SAN FRANCISCO PLANNING DEPARTMENT

NOTICE OF PUBLIC HEARING

PROJECT INFORMATION	APPLICANT INFORMATION
Project Address: 34 Steiner Street Cross Street(s): Hermann Street Block /Lot No.: 0875 / 013 Zoning District(s): RTO / 40-X Area Plan: Market and Octavia Record Number: 2019-0002272VAR	Applicant: Toby Morris Company: Kerman Morris Architects Applicant Address: 139 Noe Street City, State: San Francisco, CA 94114 Telephone: (415) 749-0302 E-Mail: toby@kermanmorris.com

PRE-APPLICATION MEETING REQUEST
34 Steiner Street.
Alterations
Existing: 7-Unit Residential
Proposed: 9-Unit Residential
2016 California Building Code
BPA #2018-0912-9872

3 SECOND FLOOR - LIFE SAFETY PLAN (24 OCCUPANTS)
3/32" = 1'-0"

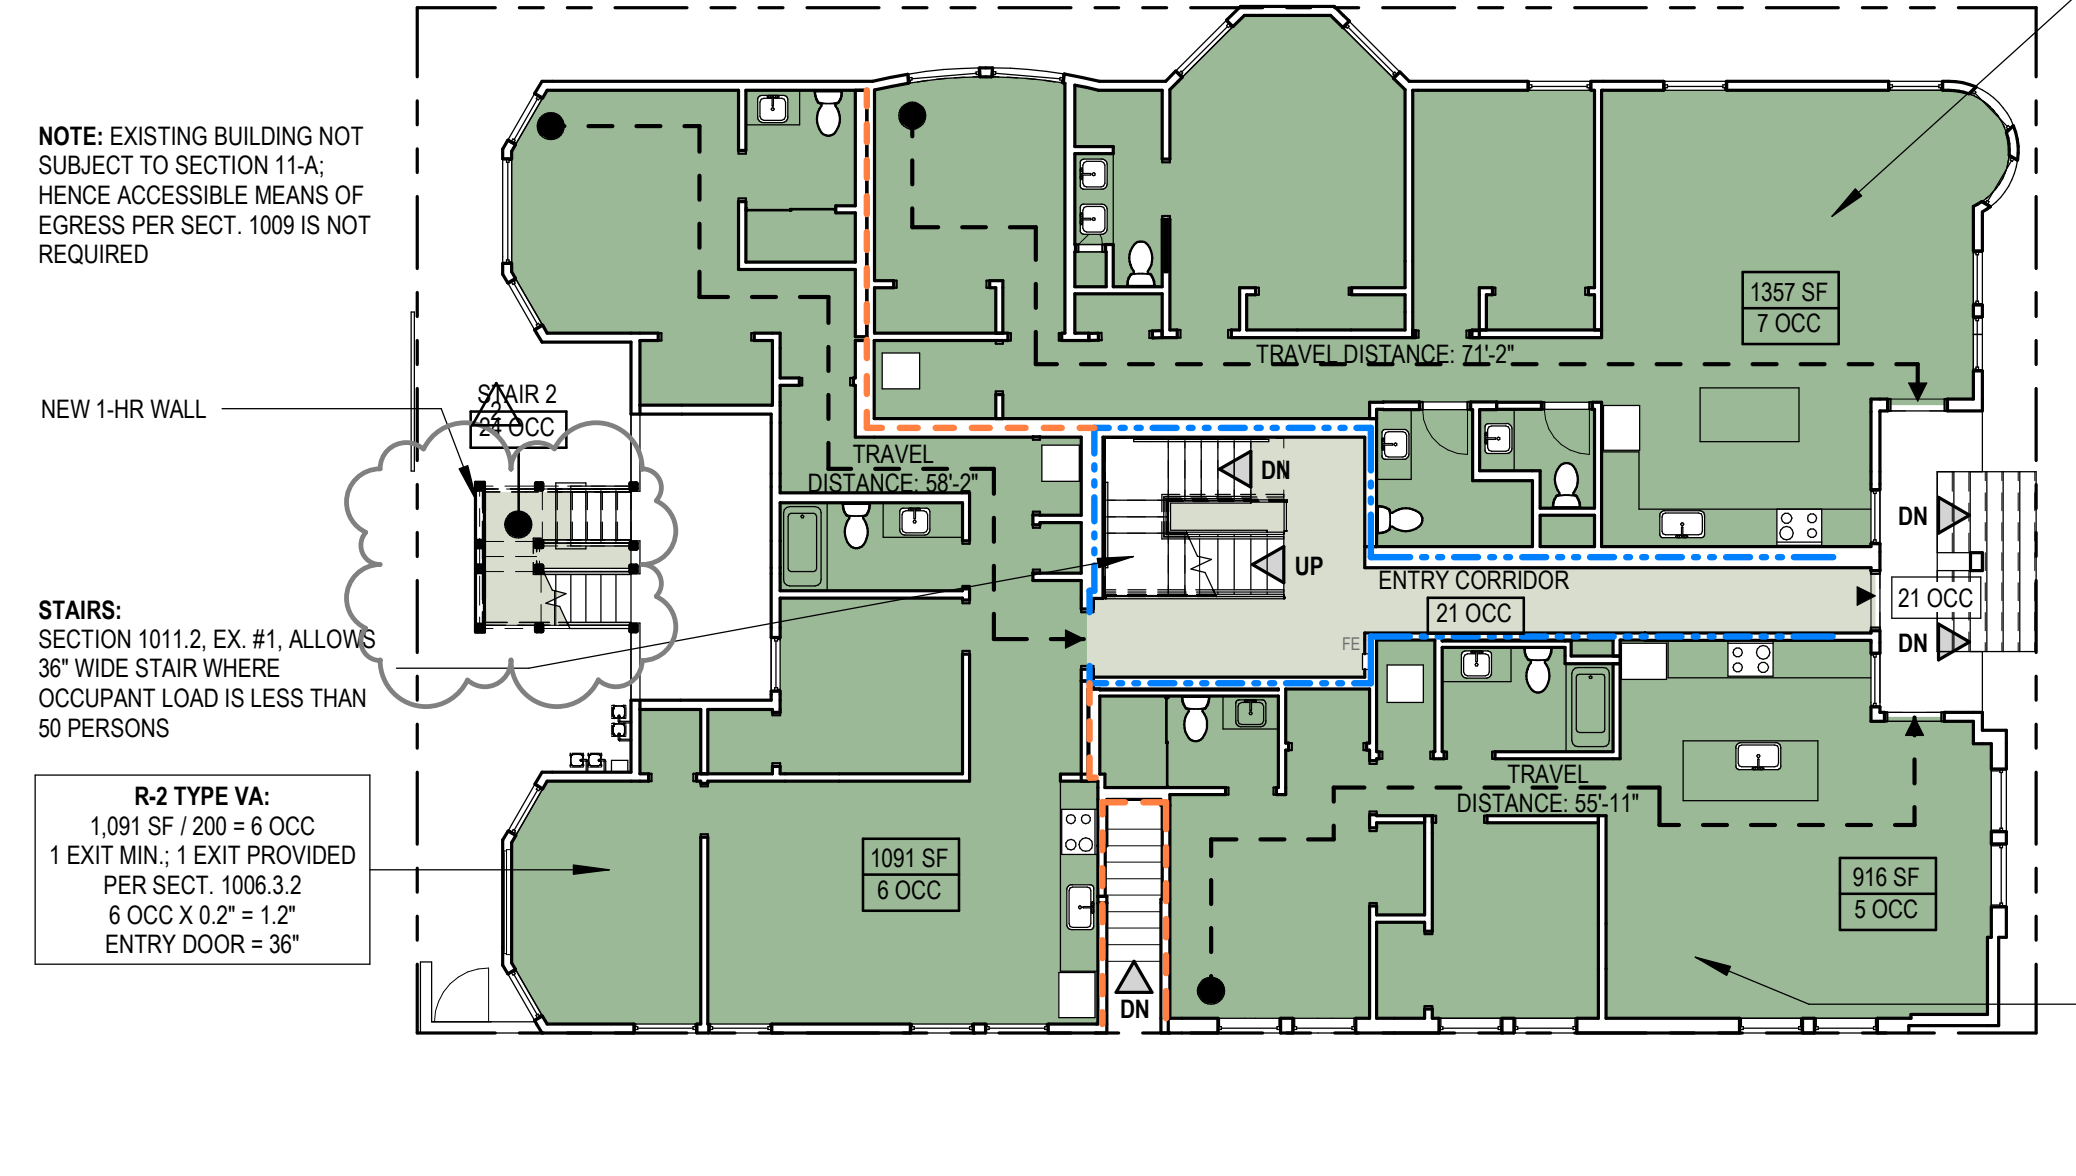
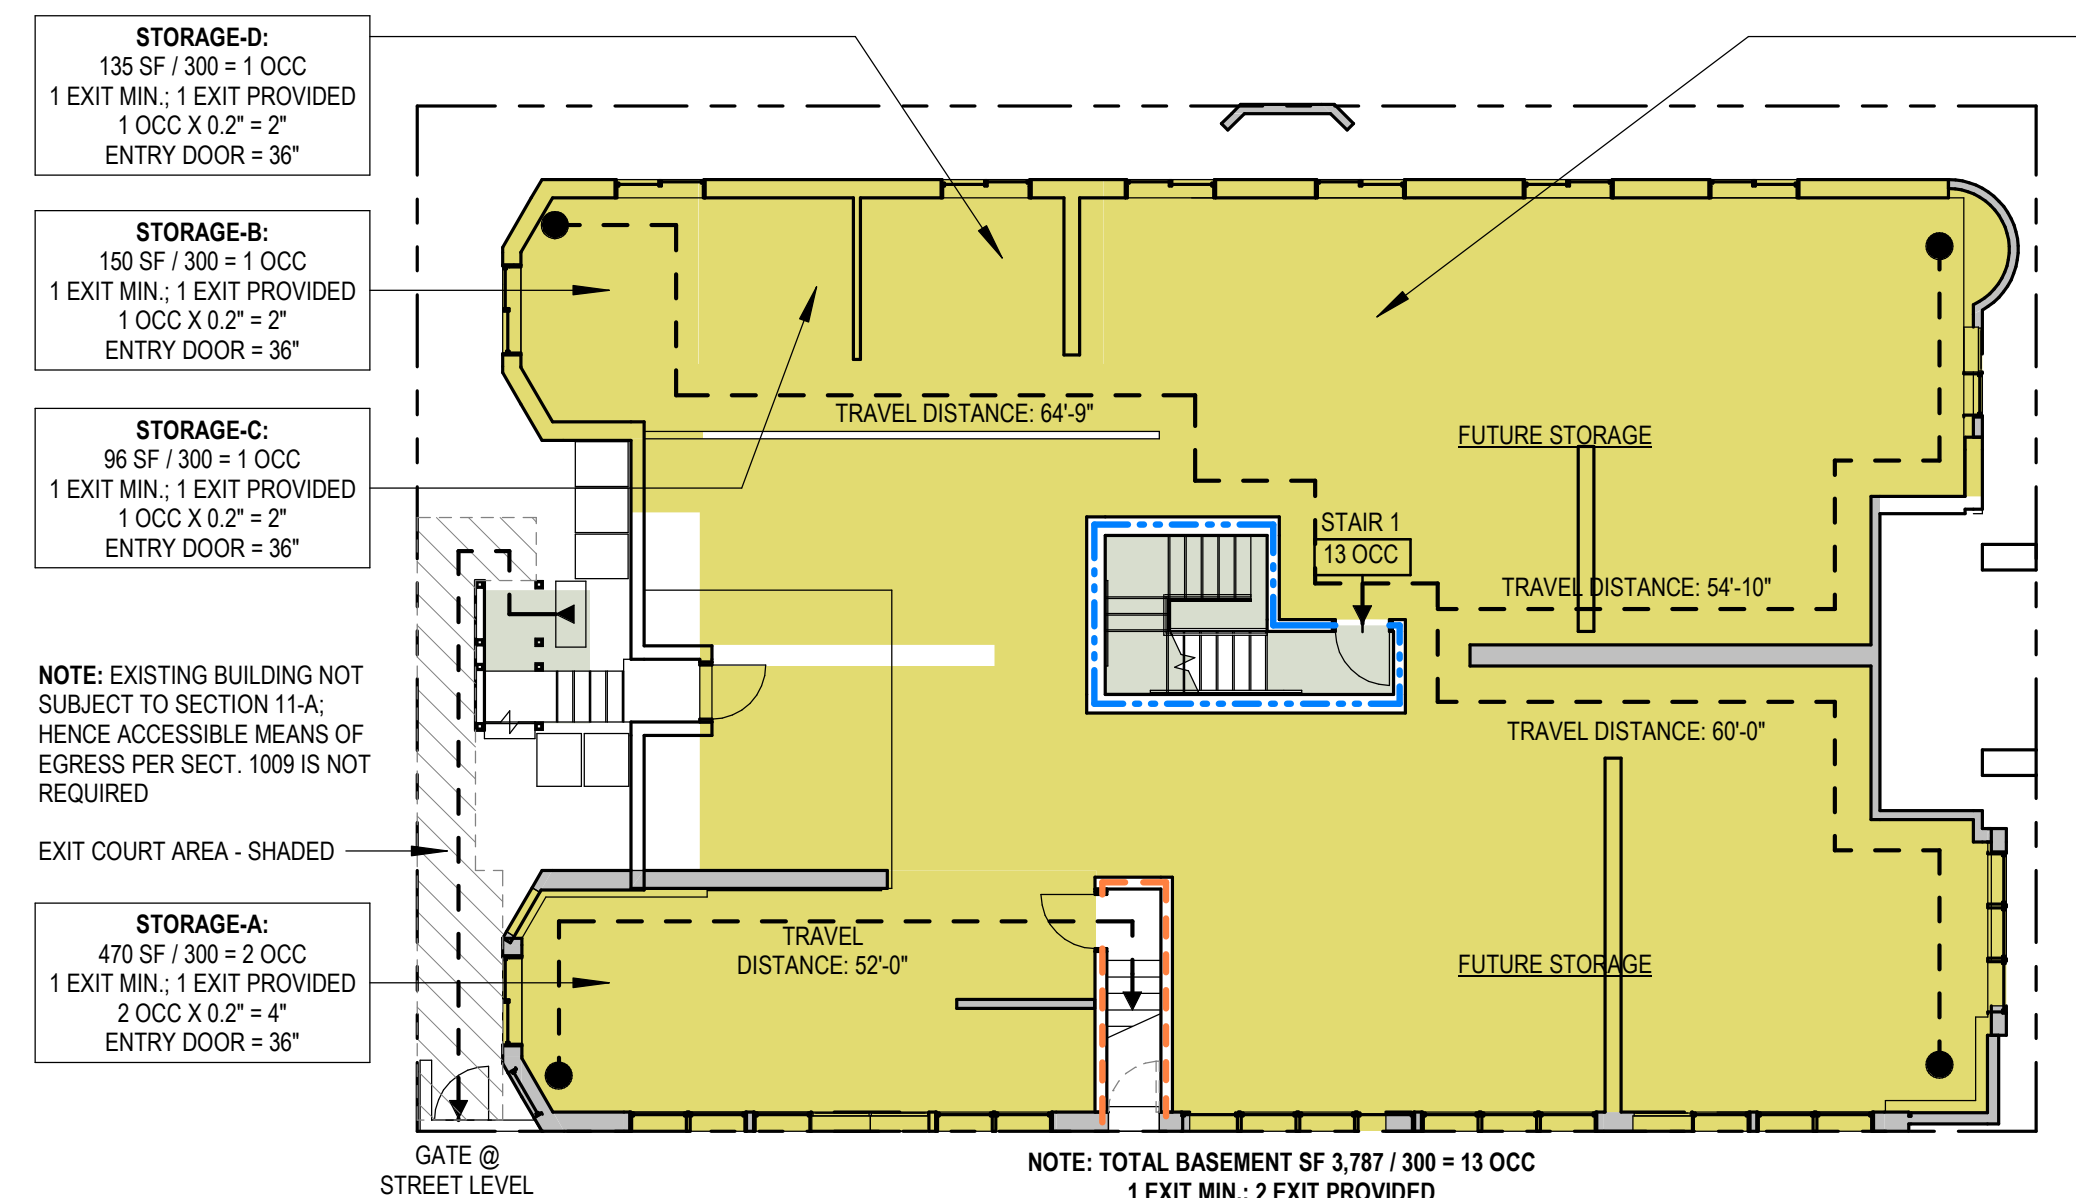
The existing partially excavated basement is proposed for full excavation and new foundations (see A2.01) to provide for storage (occupant load 300). See G0.03 Existing Plans. The basement is proposed to have 2 exits (serving approximately 13 occupants); the exits are separated by 1/3 the overall diagonal dimension of the basement area served per section 1007.1.1, exception #2 in this fully sprinklered building. Please confirm that the proposed 2 exits are sufficient.

Confirmed: Subject to review at Plan Check.

EXISTING /
 DEMO -
 BASEMENT
 PLAN

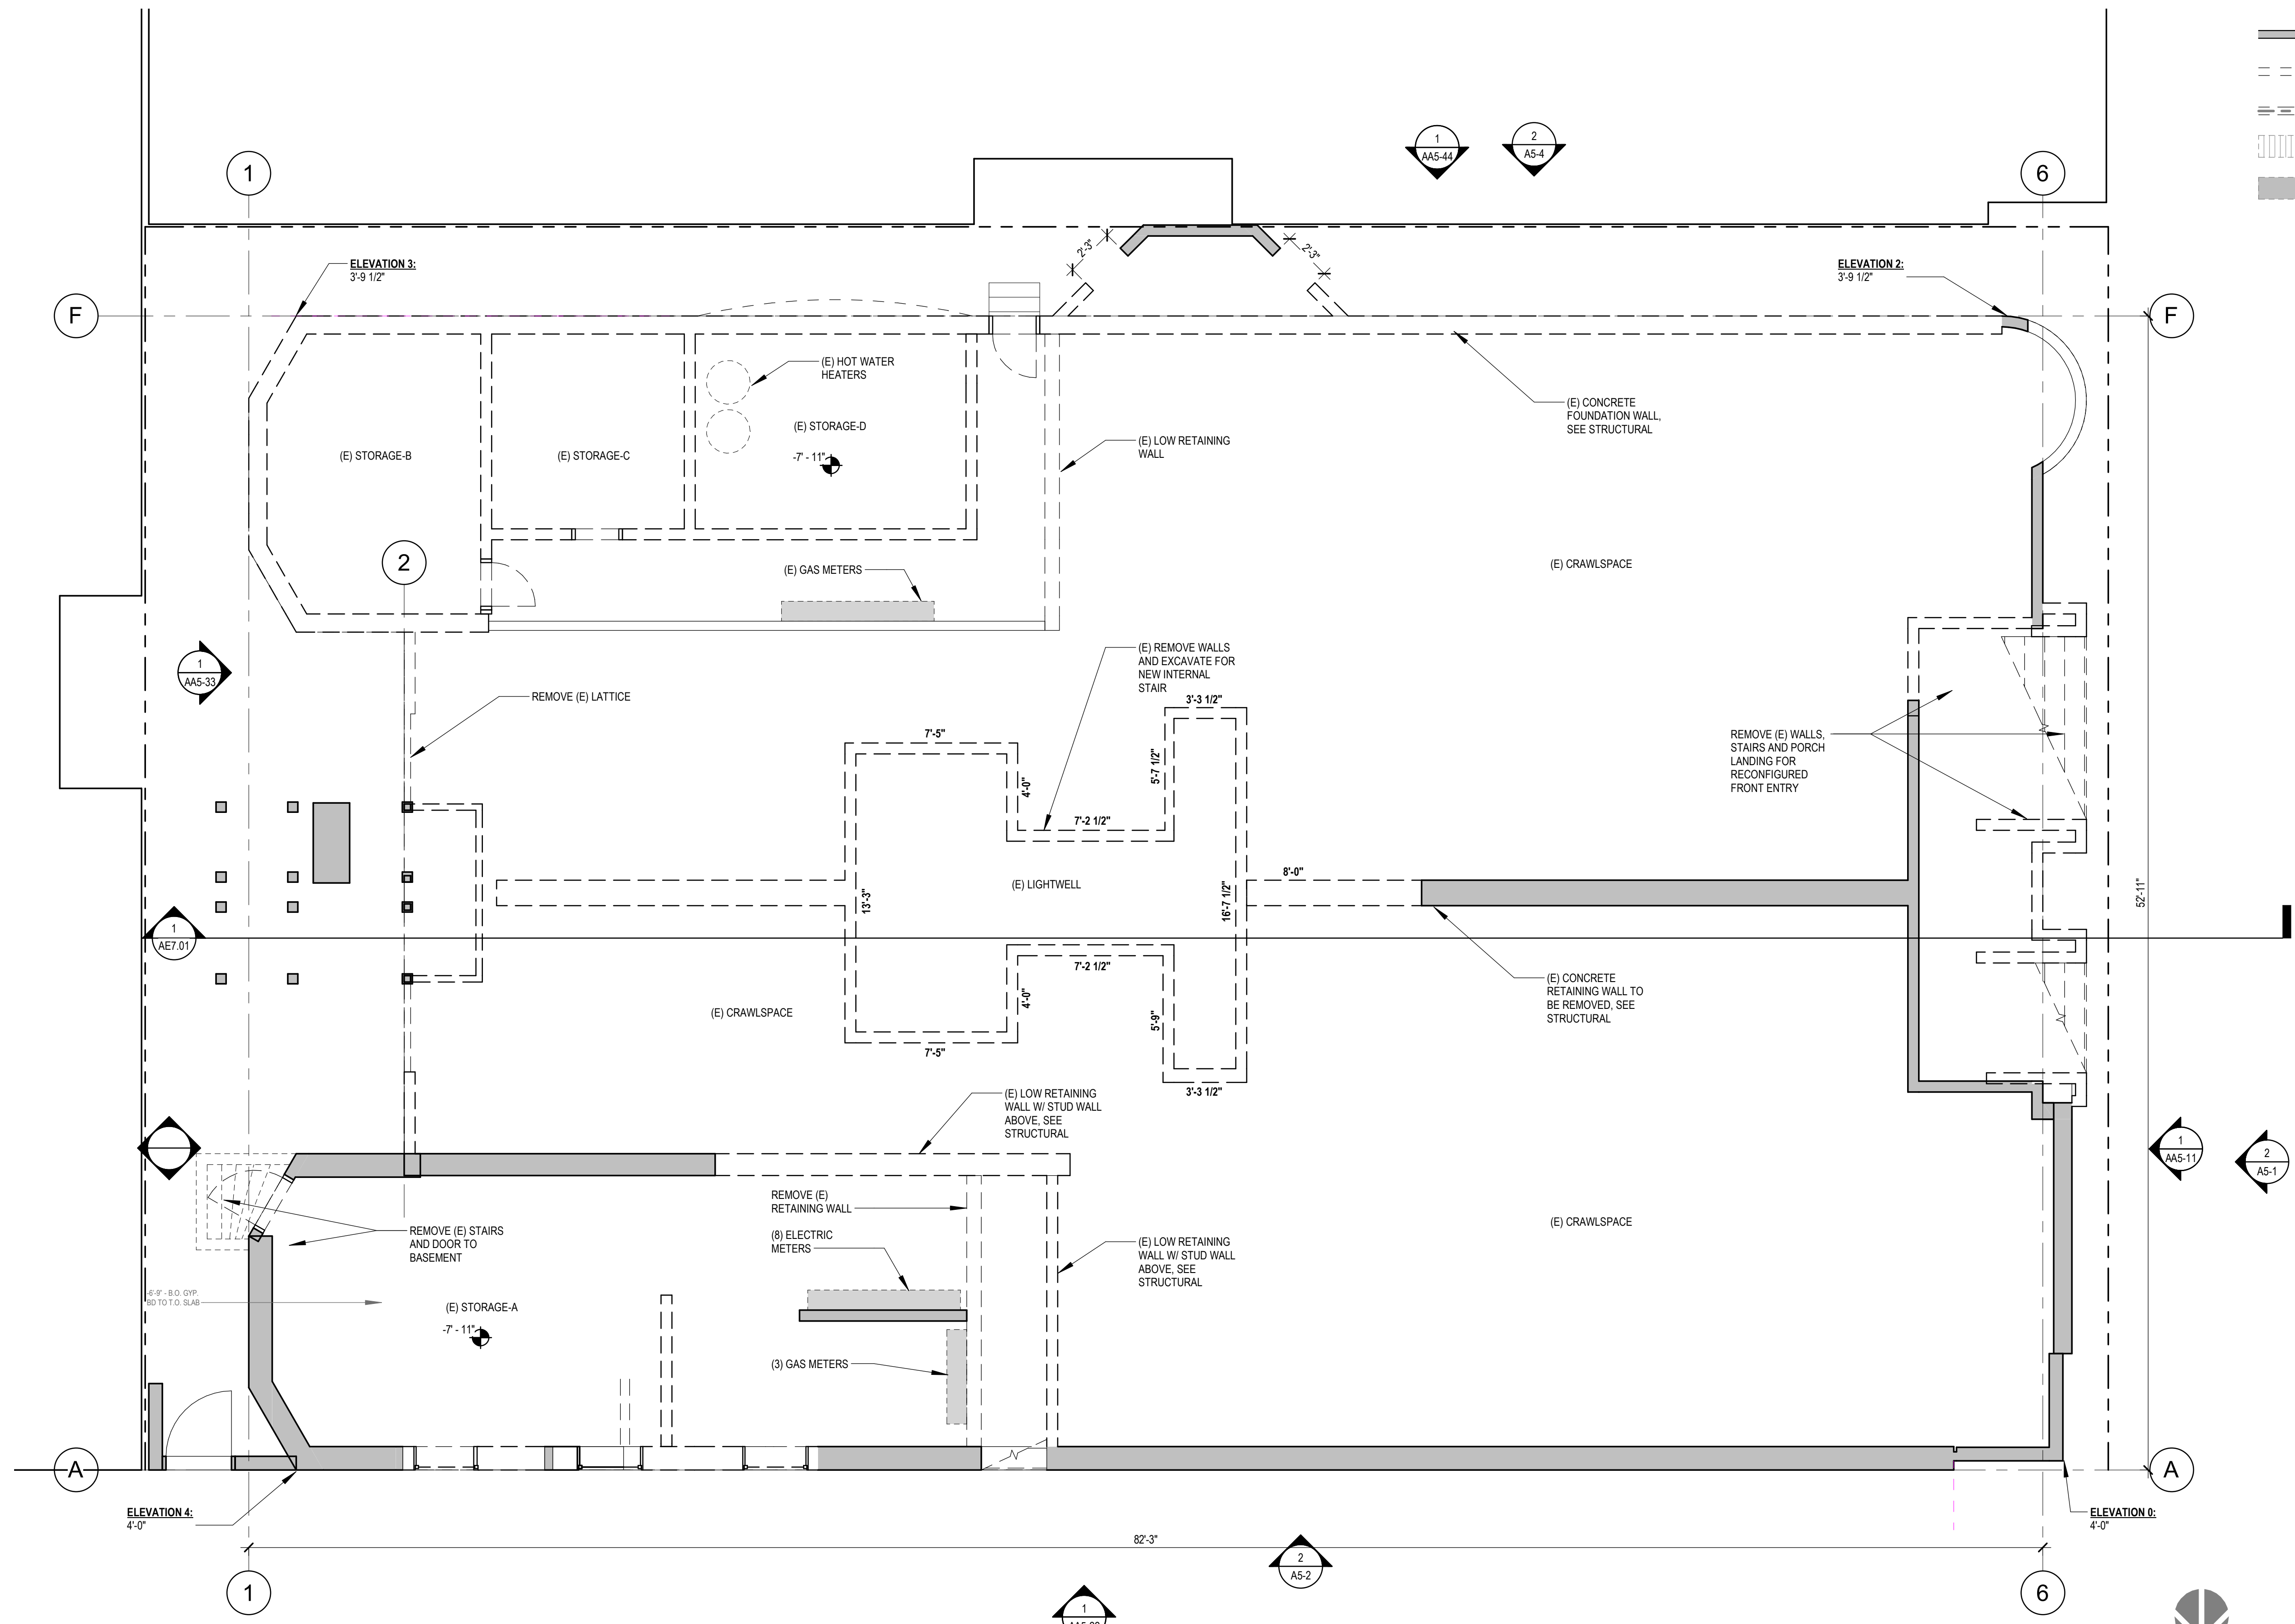
Please confirm that the subject building based on provided grade plane information will be considered 3 stories over basement. Refer to AE2.01, AE7.01, A2.01, and A7.01.

OK

To be confirmed at Plan Check
